**STAFF REPORT
FOR THE HISTORIC REVIEW BOARD**

FILE NUMBER: HDR-25-01

REQUEST: Class II Historic Design Review of the Historic City Hall building at 28825 Willamette Drive to amend the previous design review approval (DR-22-03) and remove the proposed steel awnings from the front and south side of the building.

Amend the previous Class II Design Review approval (DR-22-03) to remove the awnings as required during SHPO review of the project.

ELEVATIONS

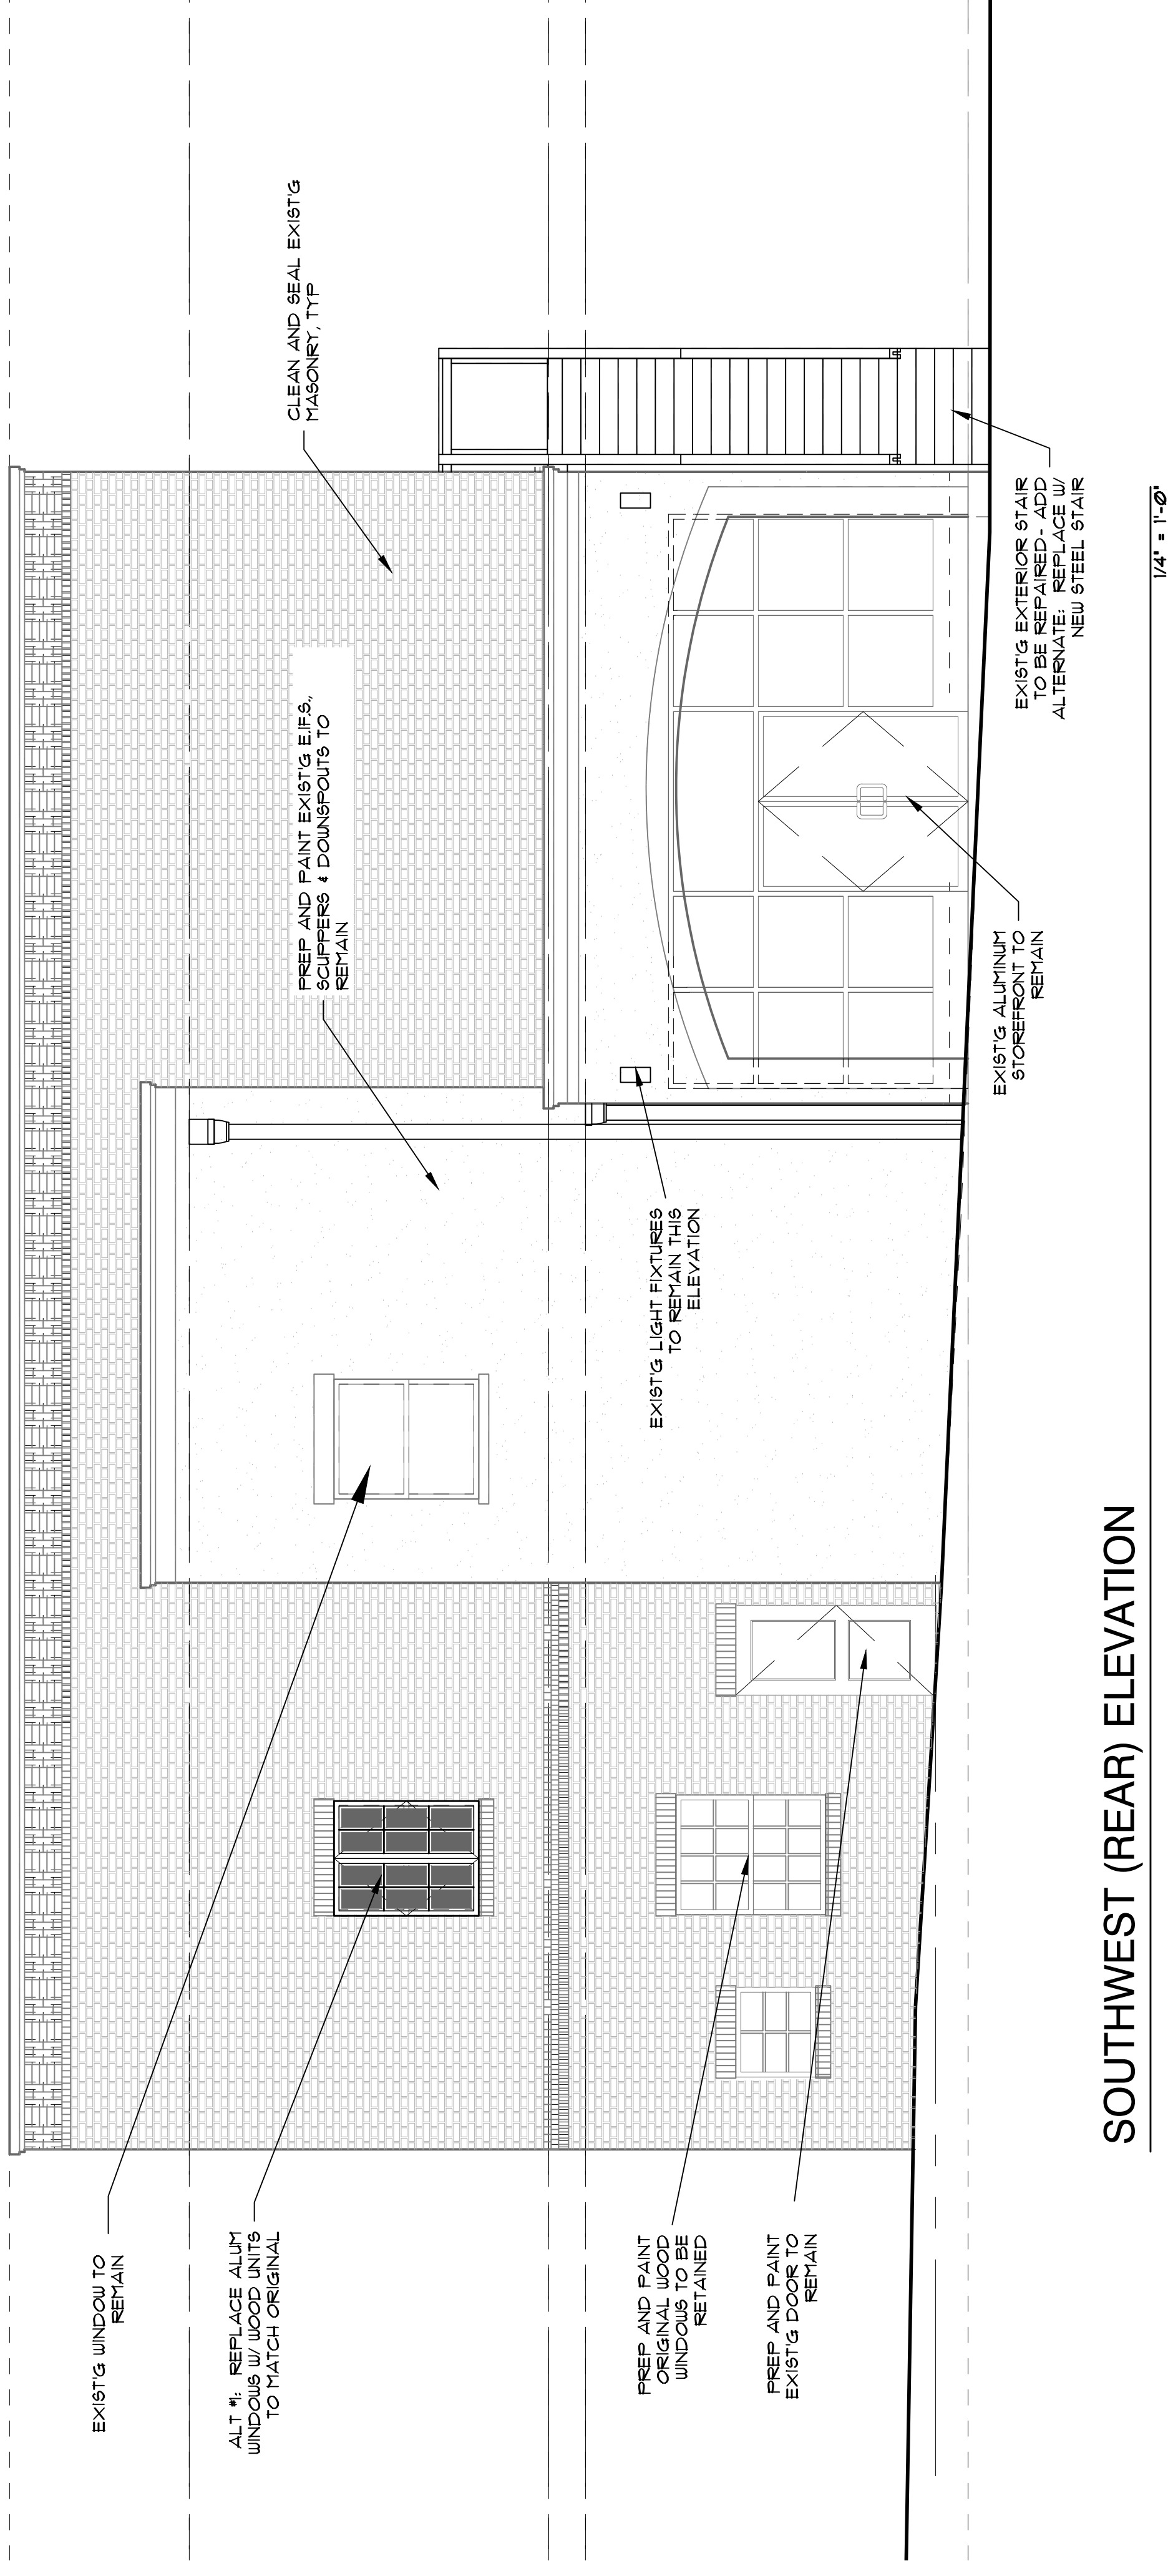
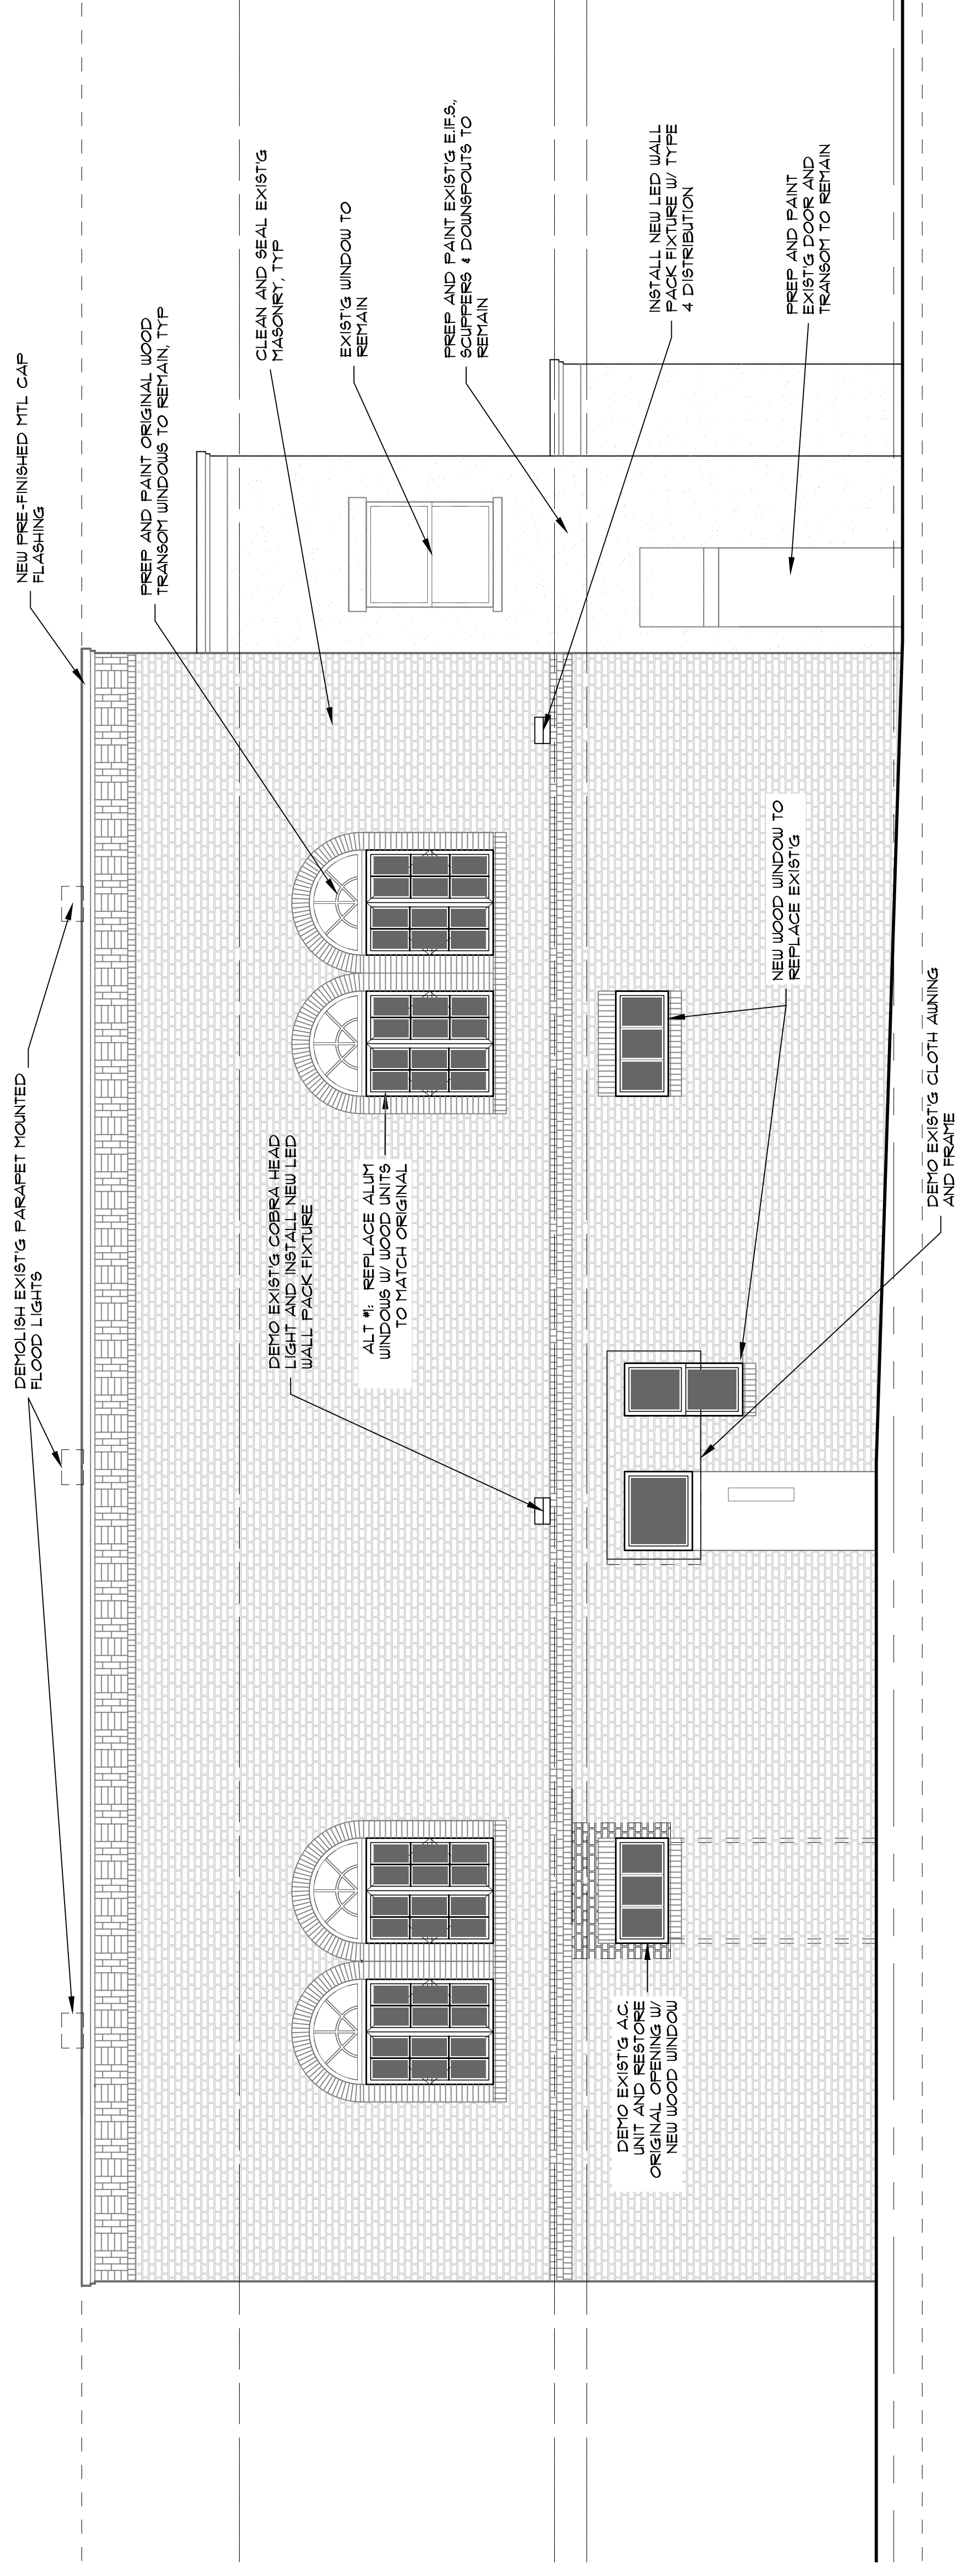
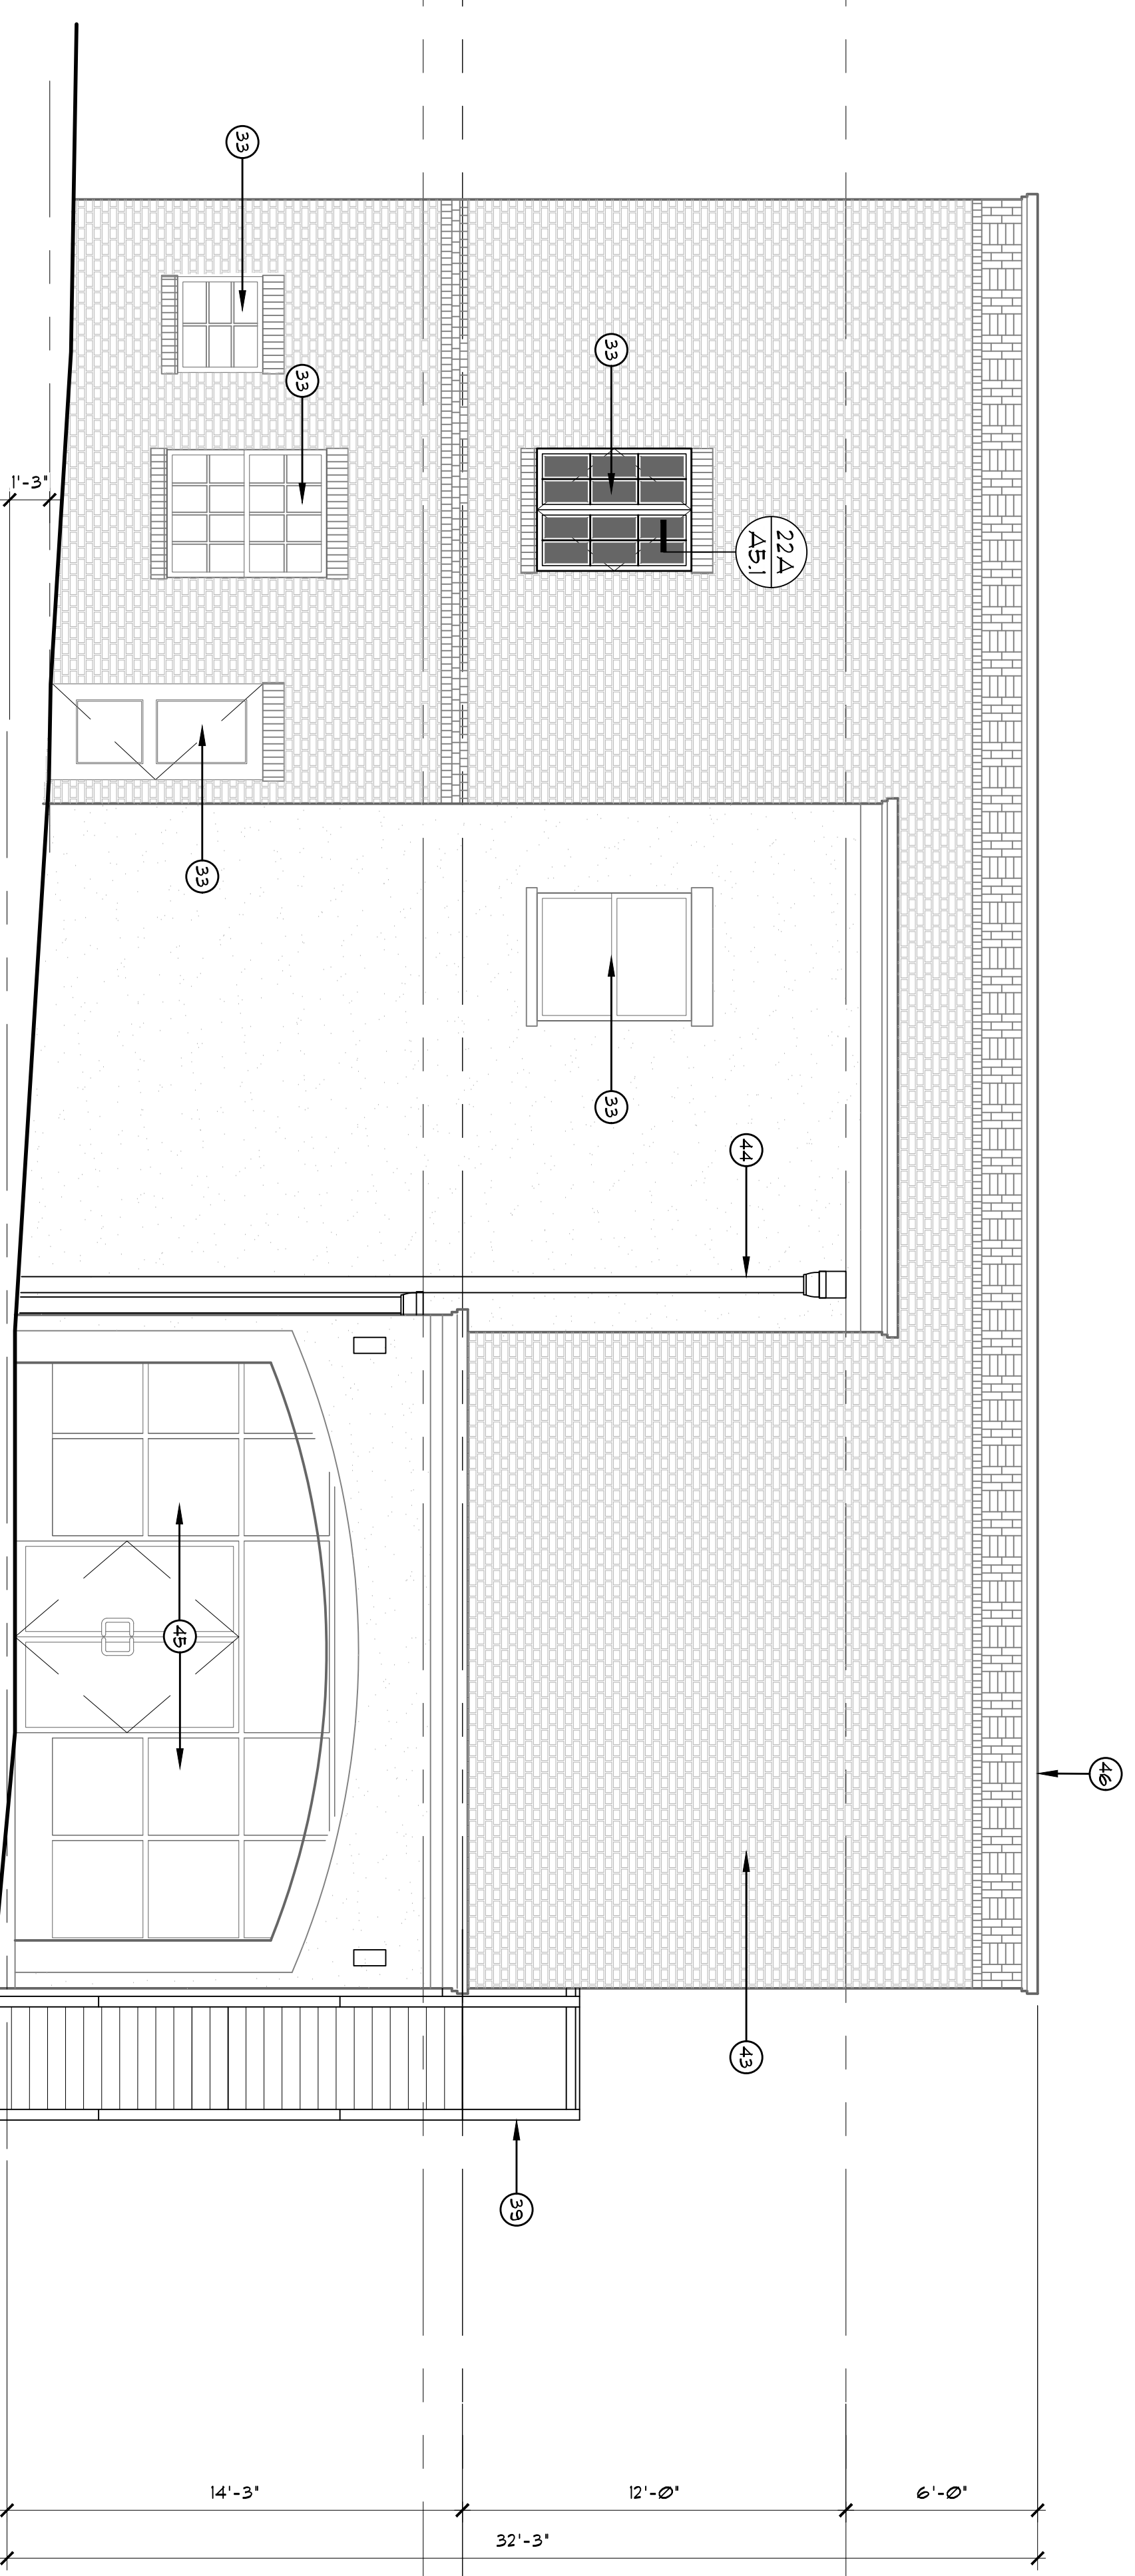
“Regarding the awning, since historically the photos do not indicate a canopy and the submitted materials explain the decision to not install an operational awning, the proposed design of the permanent canopy over the storefronts is incompatible with the historic appearance. If a smaller version was wanted to provide shelter over an entryway, it would be acceptable to place one over the middle entryway since that section has already had significant changes.”

- Regarding the awning, since historically the photos do not indicate a canopy and the submitted materials explain the decision to not install an operational awning, the proposed design of the permanent canopy over the storefronts is incompatible with the historic appearance. If a smaller version was wanted to provide shelter over an entryway, it would be acceptable to place one over the middle entryway since that section has already had significant changes.

Applicant Response: The building has been restored as approved by the Historic Review Board in the DR-22-03 Class II Design Review, except the approved steel awnings on the front of the building were removed as the State Historic Preservation Office (SHPO) found them incompatible with the historic appearance and required removal. Stylistic features have been preserved and incompatible features removed.

- The canopy/ awning elements were a desired addition by the Users to provide shading during the summer months and replace the current deteriorated, non-historic fabric awnings. Operable fabric awnings appear to have been installed early in the building's history at the corner of the building, but were not indicated in the original construction drawings. After much deliberation in our office, we concur with your position that the proposed elements should be omitted from the proposed Project.
